# Access Compliance Report

## Public Rights-of-Way

### (Curb Ramps)

Intersection ID: 25317	Main Street: SHADOWLAKE_DR	Cross Street: TILLERY_DR	Location:	W
ADA ID: 50BA64A88833	Ramp Type: PerpDiag	Initial Pass/Fail: Fail	Overall Compliance: No	Severity Score: 25
Codes/Mitigation Info/Possible Solution		Field Measurements/Component Compliance

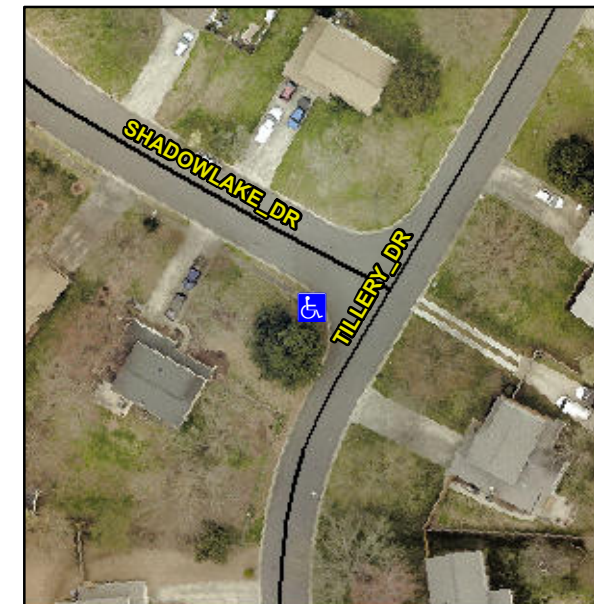
**Not Found, R304.2.2, R304.5.3**

Compliance	Description	Data	Compliance	Description	Data
N/A	Ramp Length (in)	53.0	No	Ramp Slope (%)	8.6
Yes	Ramp Width (in)	48.0	No	Ramp XSlope (%)	6.7
N/A	Flare Type LT	N/A	N/A	Flare Type RT	N/A
N/A	Flare Slope LT (%)	N/A	N/A	Flare Slope RT (%)	N/A
N/A	Flare Traversable LT?	N/A	N/A	Flare Traversable RT?	N/A
N/A	Landing Length (in)	N/A	N/A	DWS Provided?	N/A
N/A	Landing Width (in)	N/A	N/A	DWS Contrast?	N/A
N/A	Landing Slope (%)	N/A	N/A	DWS Length (in)	N/A
N/A	Landing X Slope (%)	N/A	N/A	DWS Full Width?	N/A
N/A	Landing Curb? (Y/N)	N/A	N/A	DWS Offset (in)	N/A
N/A	Shared Landing?	N/A			
N/A	Gutter Ponding?	N/A	N/A	Gutter Slope (%)	N/A
N/A	Gutter Lip Ht (in)	N/A	N/A	Gutter X Slope (%)	N/A
N/A	Painted X Walk1?	No	N/A	Painted X Walk2?	No
	X Walk 1 Direction	To SE		X Walk 2 Direction	To NE
N/A	X Walk 1 Width (in)	N/A	N/A	X Walk 2 Width (in)	N/A
	X Walk 1 Slope (%)	1.4		X Walk 2 Slope (%)	7.6
	X Walk 1 X Slope (%)	8.2		X Walk 2 X Slope (%)	0.7

**Remove & Replace Curb Ramp With Two New Directional Ramps or Equivalent.**
